Goulds Water Technology

MODEL 3872 - WW05 Series

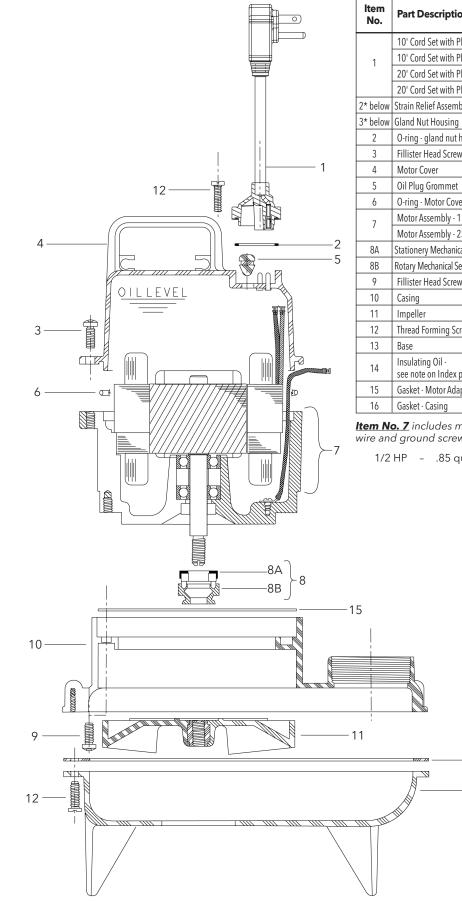
ltem No.	Part Description	Material	Qty. Req.	Before 2/1/12 Part No.	After 2/1/12 Part No.
1	10' Cord Set with Plug - 115 V	- - SJTOW - 16/3 -	1	9K207	9K531
	10' Cord Set with Plug - 230 V			9K208	9K532
	20' Cord Set with Plug - 115 V			9K533	9K533
	20' Cord Set with Plug - 230 V			9K210	9K534

* below	Strain Relief Assembly, Cord Set	Varies	1	5K113	not needed
* below	Gland Nut Housing	Thermoplastic	1	9K226	not needed
2	O-ring - gland nut housing	Buna-N, AS 568A-024		5K197	5K197
3	Fillister Head Screw - Motor Cover	AISI 300 SS	4	13K347	13K347
4	Motor Cover	Thermoplastic	1	1K257	1K257
5	Oil Plug Grommet	Buna-N	1	6K87	6K87
6	O-ring - Motor Cover	Buna-N, AS 568A-161	1	5K196	5K196
7	Motor Assembly - 115 V, 1/2 HP	Varies	1	1K284	1K284
	Motor Assembly - 230 V, 1/2 HP			1K285	1K285
8A	Stationery Mechanical Seal Assembly	Carbon/Ceramic	1	10K32	10K32
8B	Rotary Mechanical Seal Assembly				
9	Fillister Head Screw - Casing	AISI 300 SS	4	13K347	13K347
10	Casing	Thermoplastic	1	1K274	1K274
11	Impeller	Thermoplastic	1	2K494	2K494
12	Thread Forming Screw	AISI 300 SS	10	13K243	13K243
13	Base	Thermoplastic	1	1K275	1K275
14	Insulating Oil - see note on Index page	Turbine Oil - ATSM 150	-	4K432	4K432
15	Gasket - Motor Adapter	Composite	1	5K182	5K182

* Not needed after 2/1/2012.

NOTE: Pump with cord sets previous to 2/1/2012 can not be repaired after 2/1/2012.

NOTE: After 5/11, new cord design eliminates gland as seperate component.
